PROTEAM PRODUCTS

SHEET TITLE
PLUMBING FLOOR PLAN

PHASE II
100% SUBMITTAL

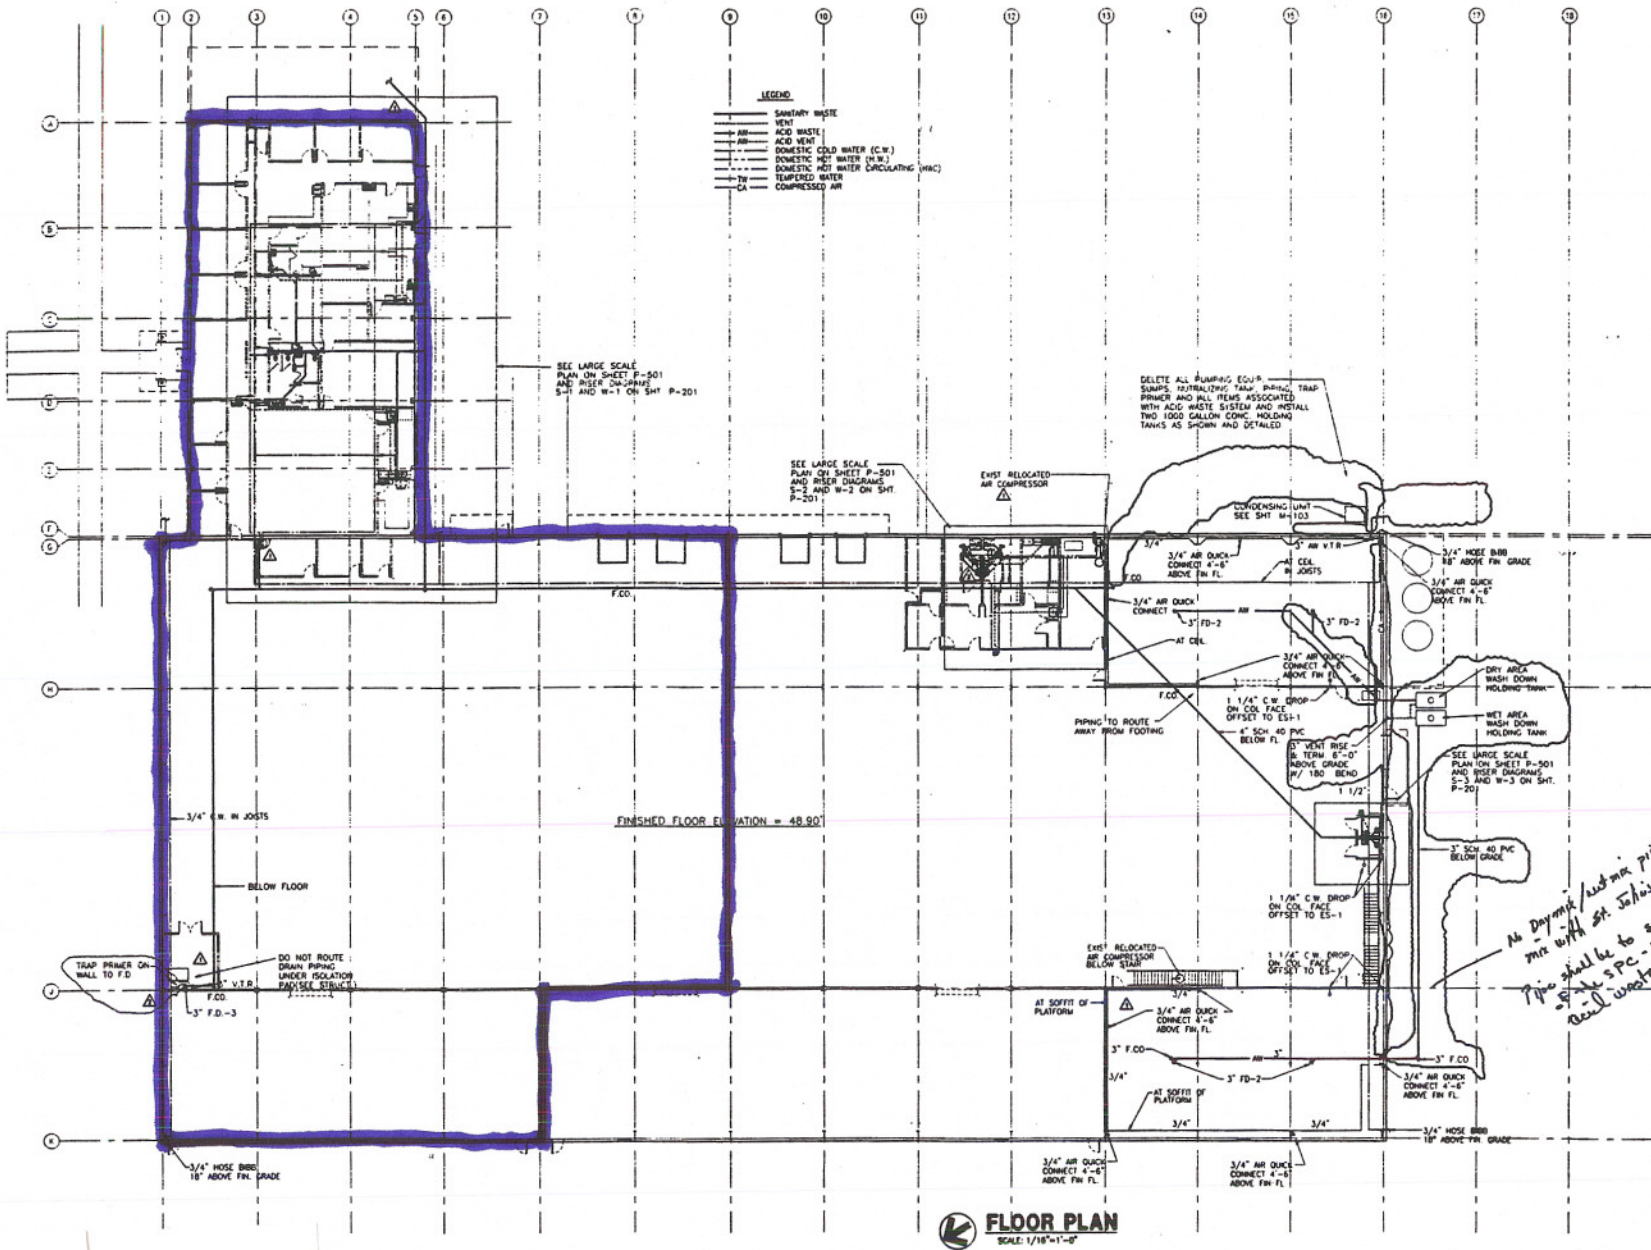
*As Dynamic / Auto mkr piping shall
 mkr with ST. John's atchy system
 Pipe shall be to section 703.6
 - 5' x 5' PC - 1177 MB. for
 acid waste*
